[Docket No. FAA-2023-1814; Project Identifier AD-2023-00773-T; Amendment 39-22541; AD 2023-17-14]

Airworthiness Directives; The Boeing Company Airplanes

Final rule; request for comments.

Figure 1 to paragraph (h)(4) – Cap seal minimum thickness (all dimensions in inches)

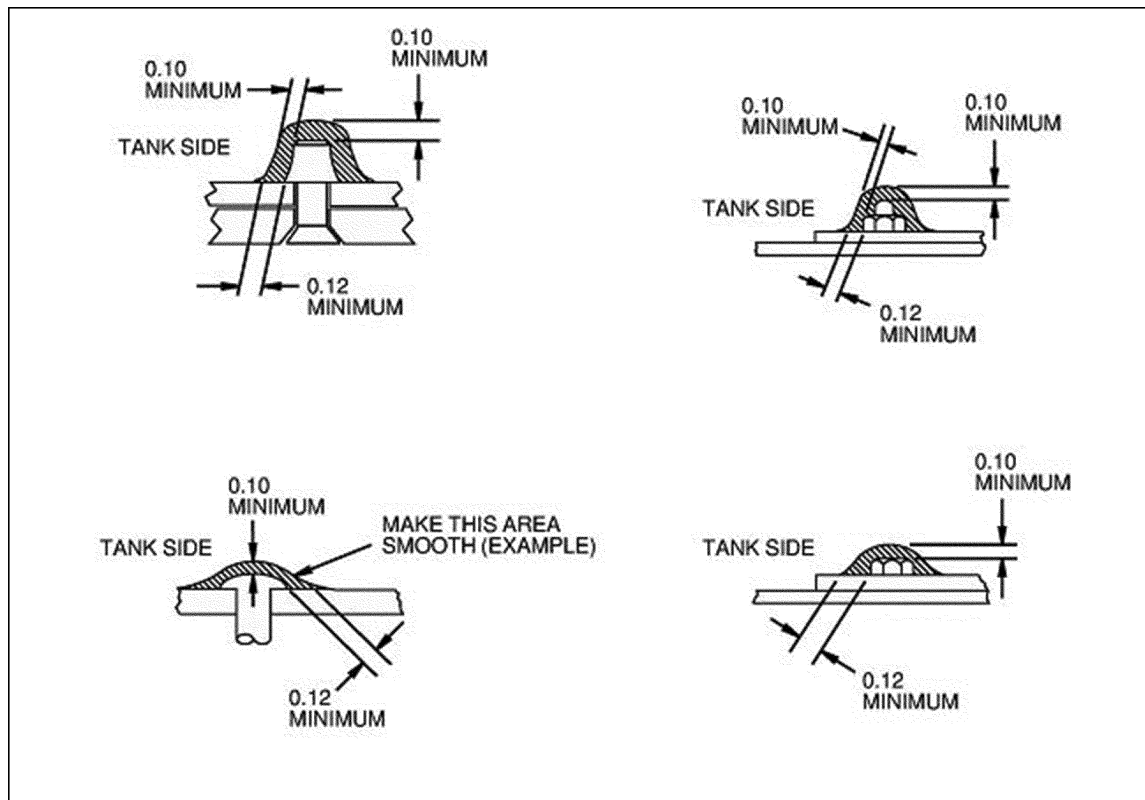
(4) During application of any cap seal to a fastener, fastener head, and fastener threads and collars, as required by this AD, the cap seal must be applied with a thickness equal to or greater than the dimensions specified in figure 1 to paragraph (h)(4) of this AD.

(6) Where Boeing Alert Requirements Bulletin 777-57A0122 RB, dated October 8, 2021, requires inspections that may require the removal of fastener cap seals, this AD requires that if the cap seal is removed, a cap seal of BMS 5-45 sealant be reapplied with a thickness equal to or greater than the dimensions specified in figure 1 to paragraph (h)(4) of this AD before further flight after completion of the inspection.

(ii) All cap seals were applied using procedures with thickness dimensions greater than or equal to those given in figure 1 to paragraph (h)(4) of this AD.

(2) If any cap seal was applied using procedures with thickness dimensions less than those given in figure 1 to paragraph (h)(4) of this AD, or if the maintenance records do not definitively specify the procedures used: At the applicable time specified in paragraph (i)(2)(i) or (ii) of this AD, replace the cap seal in accordance with the Accomplishment Instructions of Boeing Alert Requirements Bulletin 777-57A0122 RB, dated October 8, 2021, using a cap sealing procedure with thickness greater than or equal to the dimensions given in figure 1 to paragraph (h)(4) of this AD.

(3) For any cap seal that was not applied, or for any cap seal that was removed for inspections and not replaced, or if the maintenance records do not definitively specify the procedures used: At the applicable time specified in paragraph (i)(3)(i) or (ii) of this AD, apply a cap seal of BMS 5–45 sealant using an accepted method with thickness greater than or equal to the dimensions given in figure 1 to paragraph (h)(4) of this AD.
